# FINAL PLAT OF "ASHBROOK MEADOWS AT CHISHOLM CREEK"

RE: S/D 98-107 -- One-Step Final Plat of ASHBROOK MEADOWS AT CHISHOLM  
CREEK ADDITION

RE: S/D 98-107 -- One-Step Final Plat of ASHBROOK MEADOWS AT CHISHOLM  
CREEK ADDITION

**CASE NUMBER:** S/D 98-107 - ASHBROOK MEADOWS AT CHISHOLM CREEK

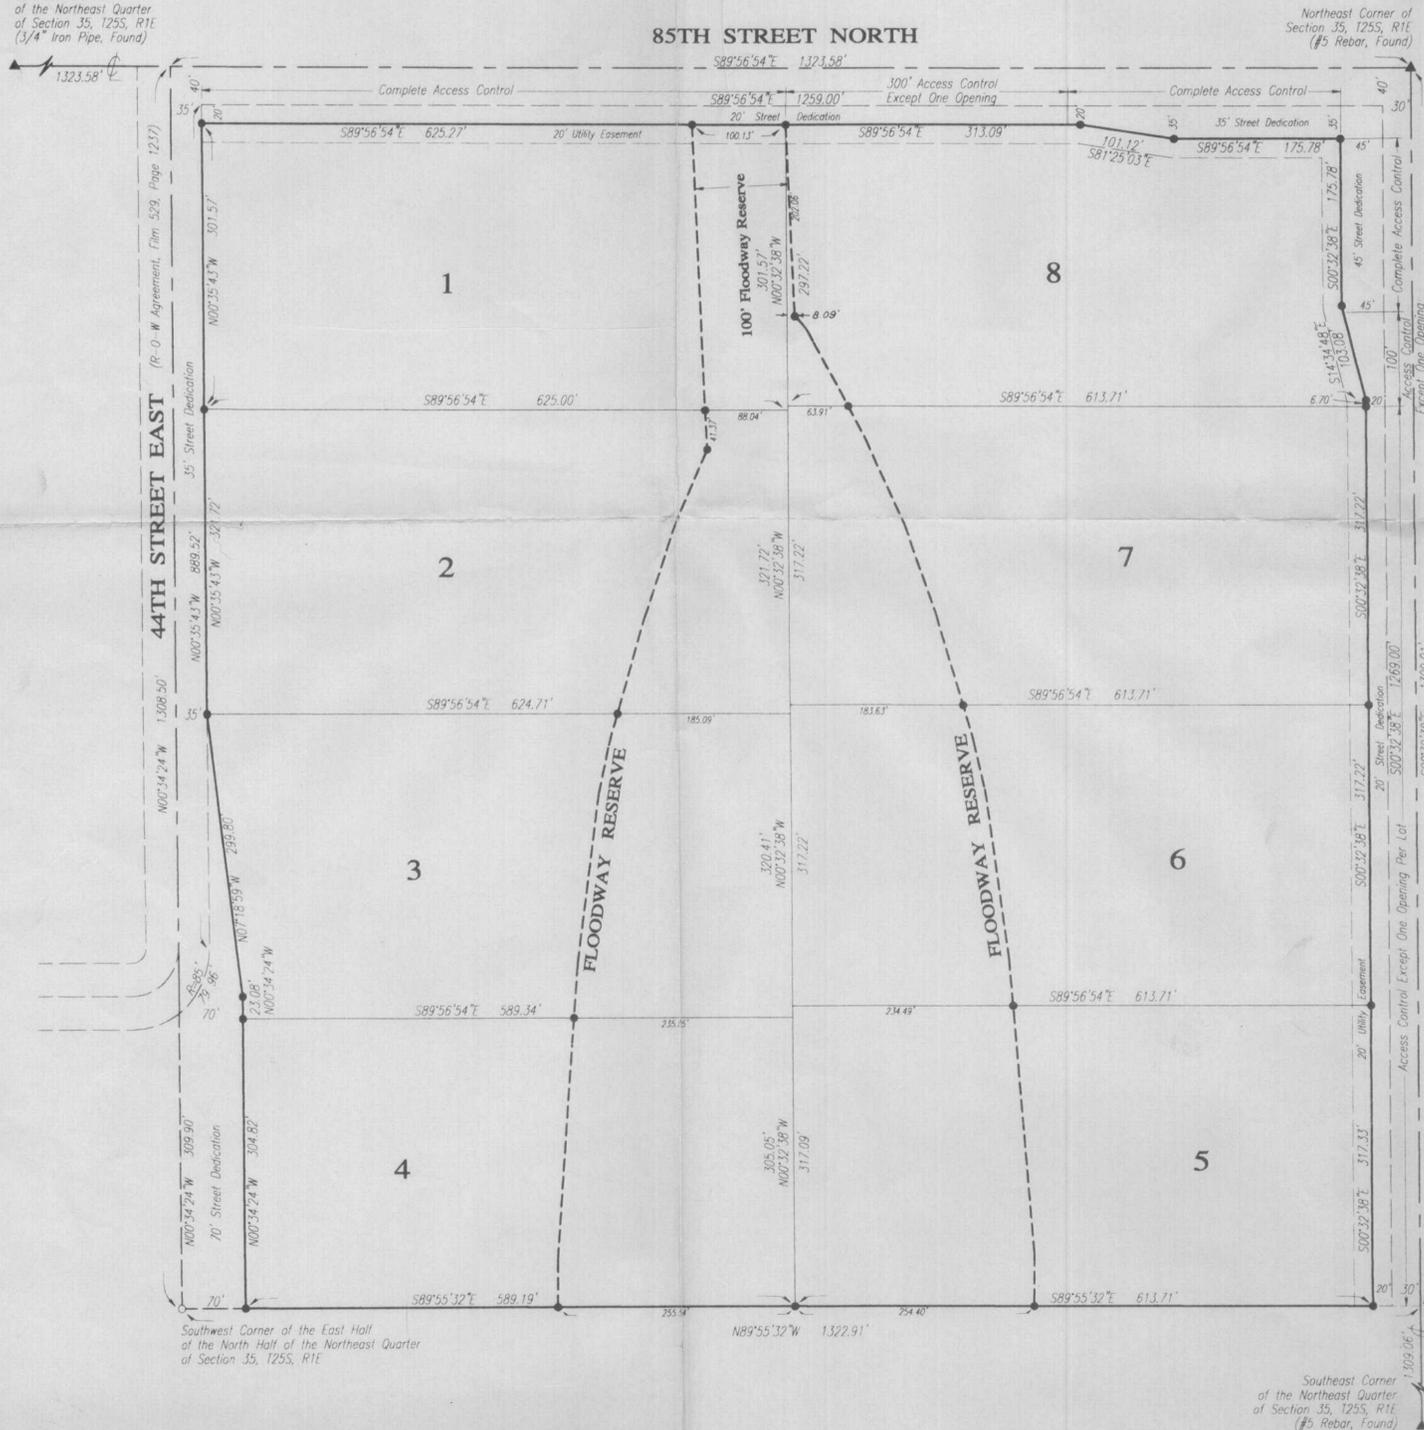
- A. Since neither municipal water nor sanitary sewer is available to serve this property, the applicant shall contact the Environmental Health Division of the Health Department to find out what tests may be necessary and what standards are to be met for approval of on-site sewerage facilities and water wells. A memorandum shall be obtained specifying approval. The lots will consist of less than 4.5 acres, in violation of the Subdivision regulations after dedication of right-of-way for adjoining streets. *The Subdivision Committee has approved a modification to the 4.5 acre minimum lot size.*

- C. County Engineering needs to comment on the status of the applicant's drainage plan. *The drainage plan is approved.*
- D. County Engineering needs to comment on the access controls. The plat denotes one access opening along 85th St. North for the lot adjoining Oliver, and one access opening per lot along Oliver.

- E. The Subdivision regulations require a 50-ft half street right-of-way for section line roads. The plat denotes a contingent right-of-way dedication for Oliver (currently 30-ft half-street right-of-way) and 85th St. North (currently 40-ft half street right-of-way). County Engineering needs to comment on the need for an outright dedication. *An outright dedication of right-of-way is required for Oliver and 85th St. North.*

- G. The City Council signature block needs to be added as this plat is located within three miles of the City.
- G. The applicant shall install or guarantee the installation of all utilities and facilities which are applicable and described in Article 8 of the MAPC Subdivision Regulations. (Water service and fire hydrants required by Article 8 for fire protection shall be as per the direction and approval of the Chief of the Fire Department.)

- M. Recording of the plat within thirty (30) days after approval by the City Council and/or County Commission.
- N. The representatives from the utility companies should be prepared to comment on the need for any additional utility easements to be platted on this property. *Southwestern Bell has requested additional easements.*
- O. The applicant is reminded that a disk shall be submitted with the final plat tracing to the Planning Department detailing this plat in digital format in Release 13 version of Autocad. This will be used by the City and County GIS Department.
- P. An access easement will need to be established for Lot 4.**
